Technical Service Bulletin: TSB180051

Released Date: 12-Jun-2024

New Gear Housing and Fuel Pump Idler Shaft

Figure 1, New Gear Housing, Part Number 5468170.

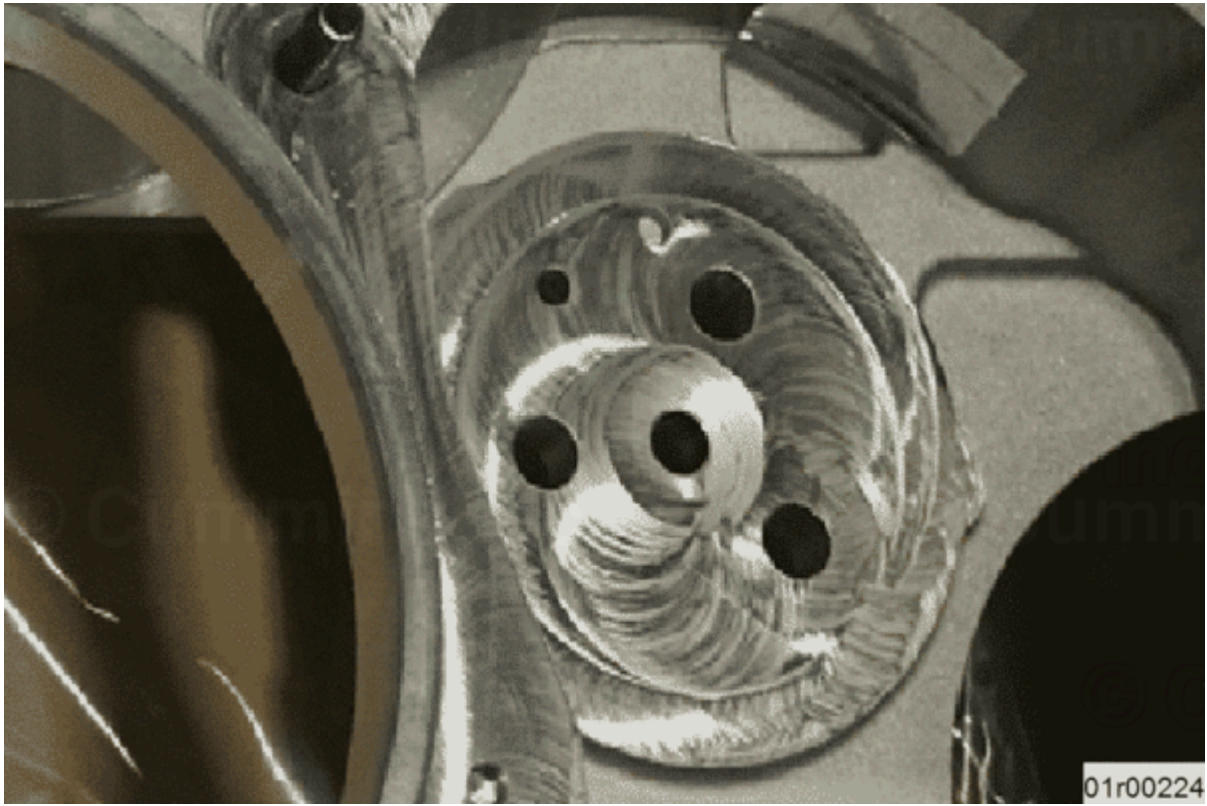
New gear housing, Part Number 5468170, can be distinguished by the 4mm [5/32 in] deep blind hole where the fuel pump idler shaft dowel fits. See Figure 1.

Figure 2, Left: Existing Fuel Pump Idler Shaft, Part Number 3686952. Right: New Fuel Pump Idler Shaft, Part Number 5484100.

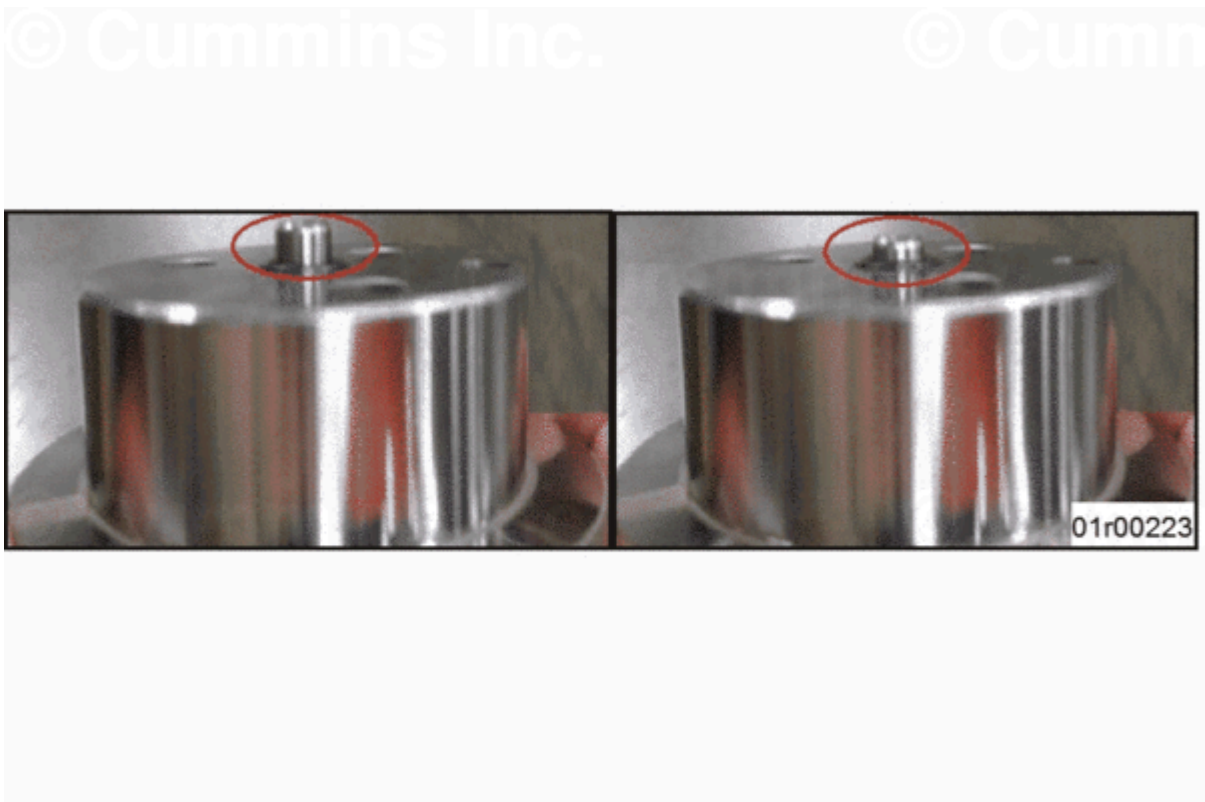
New fuel pump idler shaft, Part Number 5484100, can be distinguished by dowel protrusion decreased from 6mm [15/64 in] to 3mm [1/8 in]. See Figure 2.
